RESPONSE TO NRC
REQUEST FOR ADDITIONAL INFORMATION
RELATED TO LICENSE RENEWAL

UNIVERSITY OF FLORIDA TRAINING REACTOR

LICENSE NO. R-56
DOCKET NO. 50-083

**UFTR RESPONSES
TO USNRC
REQUEST FOR ADDITIONAL INFORMATION
DATED
APRIL 6, 2005**

Figure 5-4 Schematic of UFTR Secondary Water Cooling System.

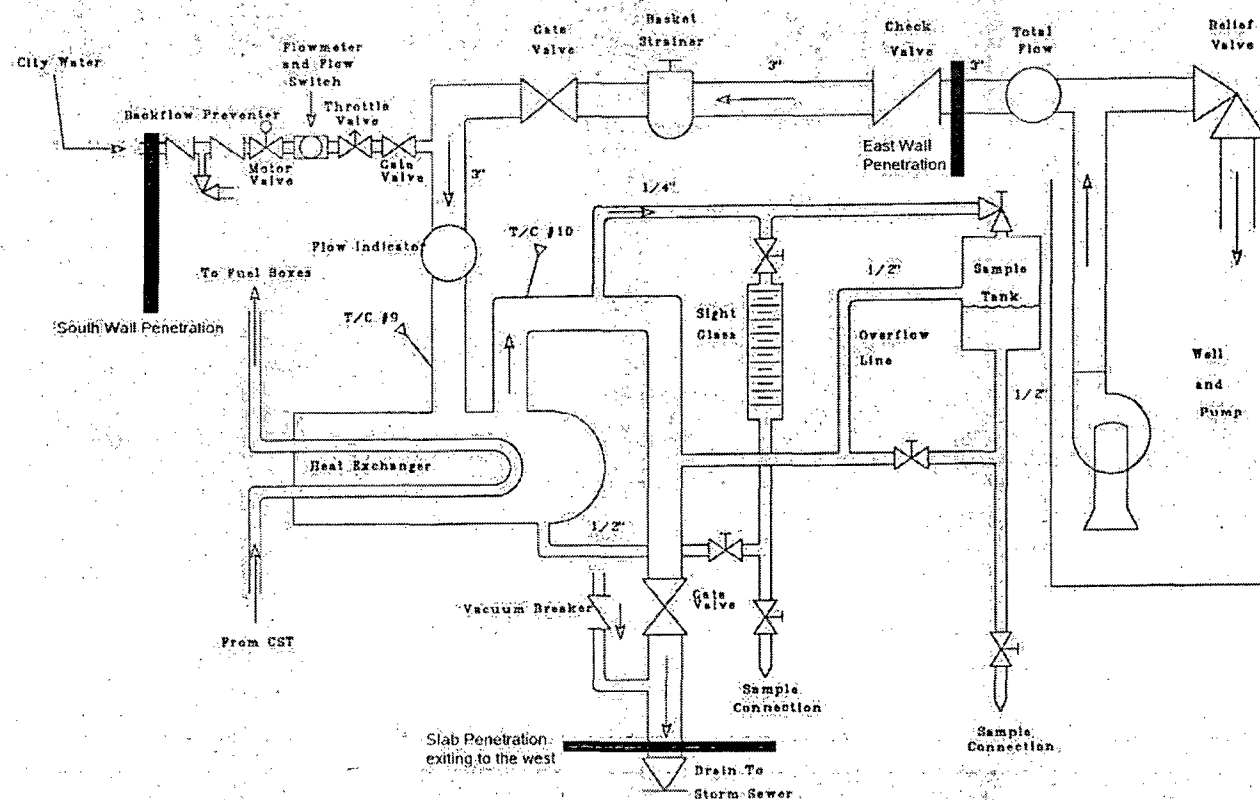
- a. *Provide sketches or layout drawings to depict the location of the primary coolant system and associated systems (i.e. secondary coolant, primary coolant cleanup and primary coolant makeup water systems) with respect to the building structures of the reactor building. Specifically, identify the portions of these systems including associated major components that are located inside and outside of the reactor building confinement.*

The sketches for the primary and secondary systems are given in Figures 5-1 and 5-2 in the SAR, respectively. The entire primary coolant loop is located within the reactor building. The points where the secondary coolant loop penetrates the confinement are shown in the updated figure 5-4 given in Appendix A in this document. There are three points: the well water line inlet on the east wall, the city water line (alternate cooling line) on the south wall, and the secondary outlet drain line in the equipment pit to the storm sewer drain. The city water line that is connected for alternate secondary cooling has a code-required backflow preventer; in addition the city water line enters the reactor cell at about 12 ft elevation above the floor while the connection to the reactor secondary cooling heat exchanger line is at least 2 feet below floor level making backflow with radioactive contamination even less likely.

Appendix A: Schematic of UFTR Secondary Water Cooling System. (in response to Q 5-1)
